[Docket No. 99-NM-65-AD]

Airworthiness Directives; Boeing Model 747 Series Airplanes Equipped With Pratt & Whitney JT9D-70 Series Engines**AGENCY:** Federal Aviation Administration, DOT.**ACTION:** Notice of proposed rulemaking (NPRM).

SUMMARY: This document proposes the adoption of a new airworthiness directive (AD) that is applicable to certain Boeing Model 747 series airplanes. This proposal would require inspections, tests, and certain modifications of the thrust reverser control and indication system and wiring on each engine, and corrective action, if necessary.

Thrust Reverser Sync-Lock Integrity Test

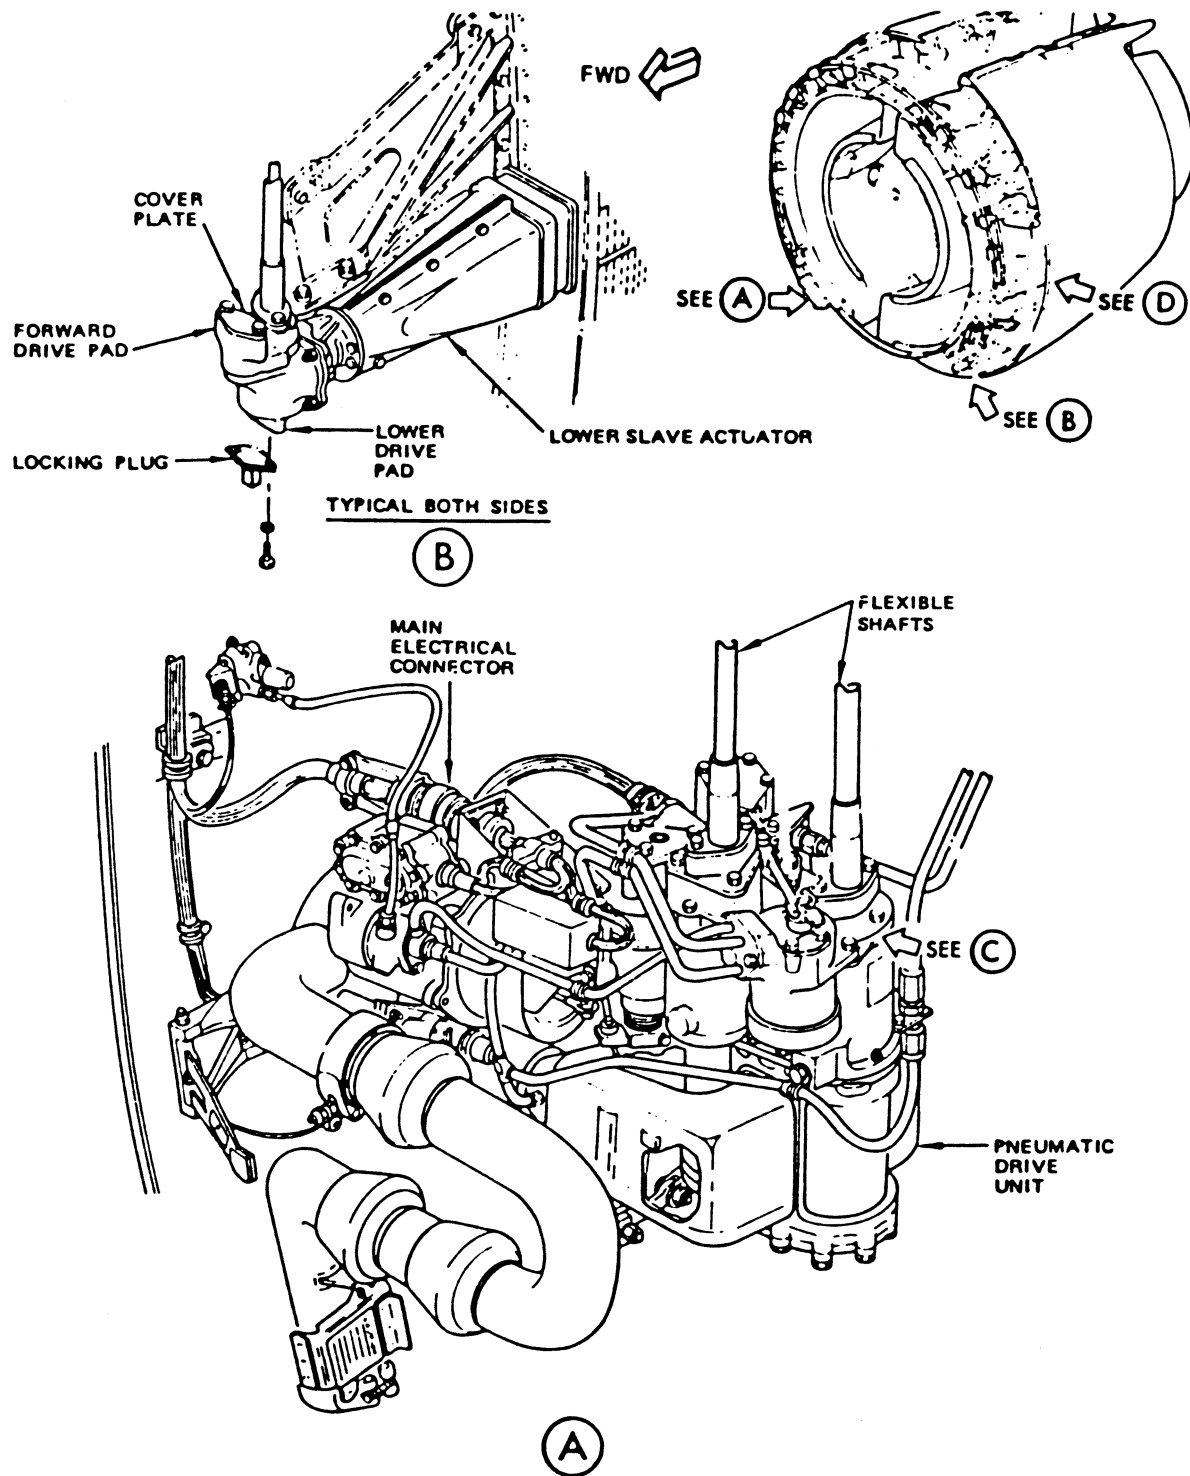
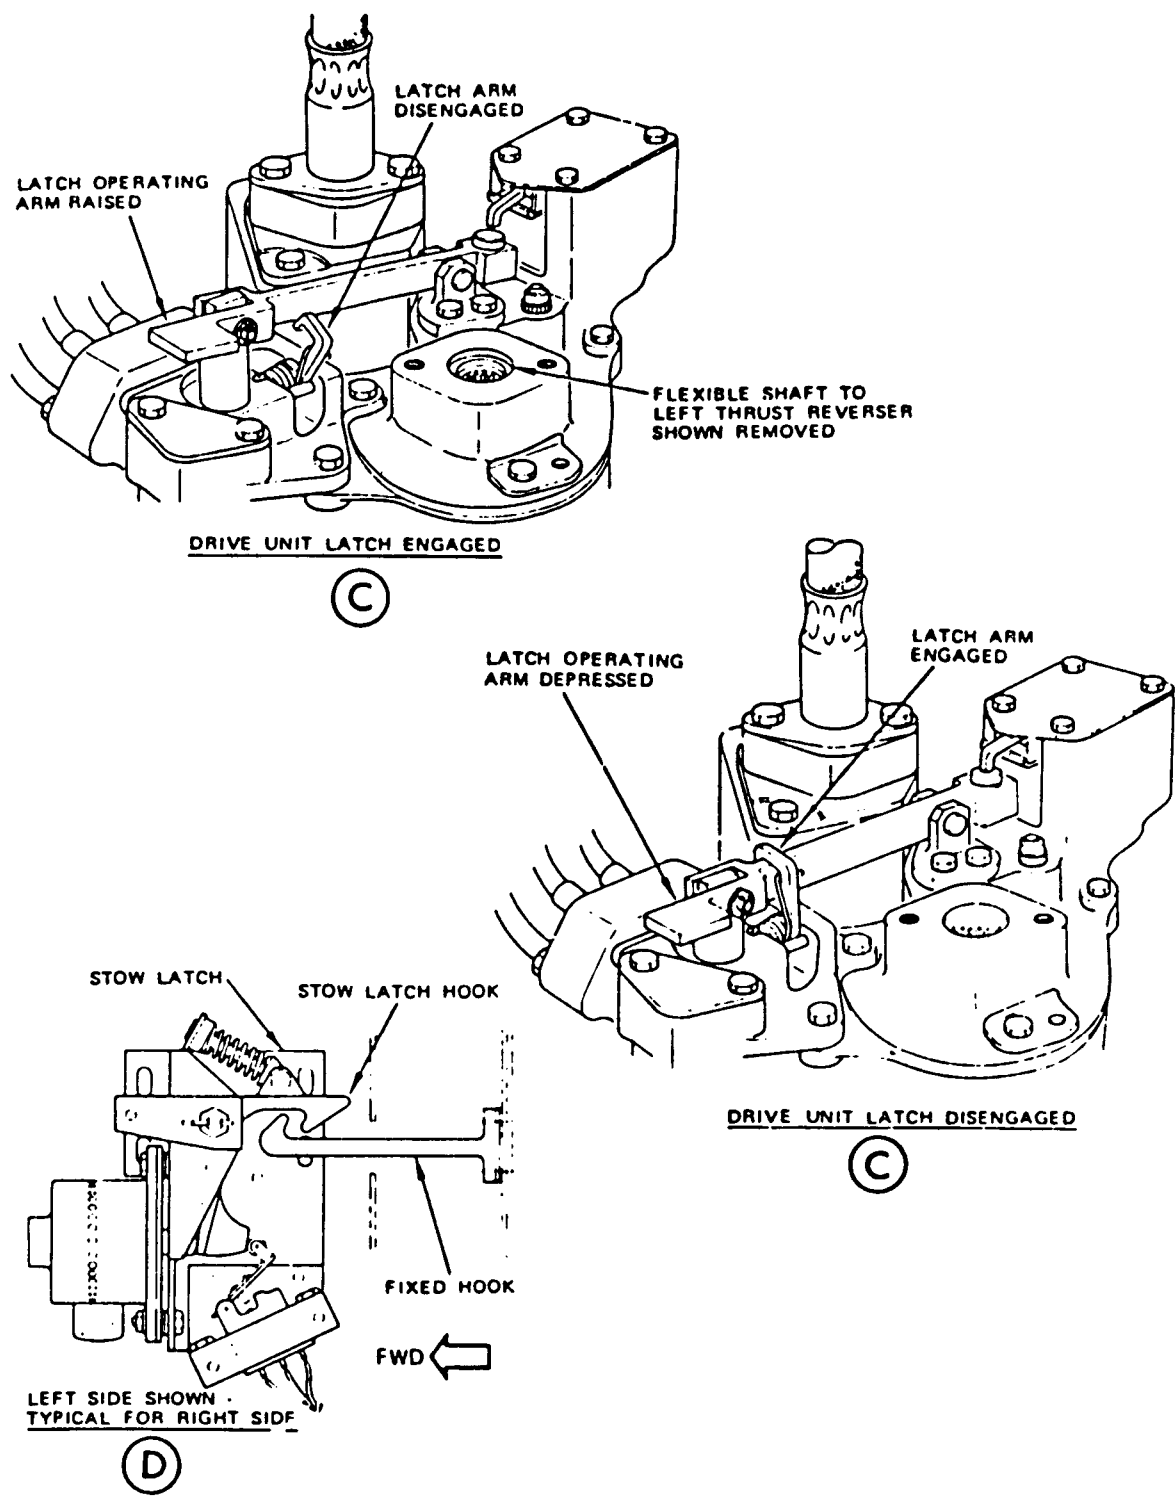
(f) Within 4,000 hours time-in-service after accomplishment of paragraph (e) of this AD: Perform a functional test to detect discrepancies of the additional locking system on each thrust reverser, in accordance with Appendix 1 (including Figures 1 and 2) of this AD. Prior to further flight, correct any discrepancy detected, in accordance with the procedures described in the Boeing 747 Airplane Maintenance Manual. Repeat the functional test thereafter at intervals not to exceed 4,000 hours time-in-service.

- (1) Open applicable T/R CONT & BLEED SYS circuit breaker on P12 circuit breaker panel.
- (2) Open fan cowl doors (Ref 71-11-02, Maintenance Practices).
- (3) Check that forward and aft circumferential latches and all tension latches are engaged and locked.

- (4) Depress drive unit latch operating arm and retain by engaging latch arm (detail C).
- (5) Disengage stow latch hook on left and right thrust reversers (detail D).
- (6) On either lower slave actuator (detail B), either remove coverplate from forward drive pad or remove locking plug from lower drive pad.
- (7) Move left-hand sync-lock lever to the unlocked position.
- (8) Using appropriate drive adapter (196K8004-1 at forward drive pad or 196K8004-3 at lower drive pad), attempt to manually deploy sleeves.

- (9) If sleeves move, replace the right-hand sync-lock.
- (10) Move left-hand sync-lock lever to the locked position.
- (11) Move right-hand sync-lock lever to the unlocked position.
- (12) Repeat step (8) above.
- (13) If sleeves move, replace the left-hand sync-lock.
- (14) Move left-hand sync-lock lever to the unlocked position.

- (15) Rotate actuator gearshaft to fully stow the sleeves.
- (16) When translating sleeves reach stowed position, check that stow latch hooks have engaged fixed hooks on both sides (detail D).
- (17) Depress latch operating arm and disengage latch arm (detail C); allow latch arm to raise.
- (18) After releasing arm, verify latch engagement by attempting to rotate feedback gear on drive unit using 1/4-inch square drive; gear shall not rotate in excess of 0.1 of a turn.

- (19) As applicable, install locking plug (with square section facing away from drive pad) or coverplate on actuator drive pad. Secure plug or plate with bolts tightened to 50-70 pound-inches.
- (20) Move both left-and right-hand sync-lock levers to the locked position.
- (21) Close fan cowl doors (Ref 71-11-02, Maintenance Practices).
- (22) Close T/R CONT & BLEED SYS circuit breaker.
- (23) Repeat the sync-lock integrity test on all remaining thrust reversers.
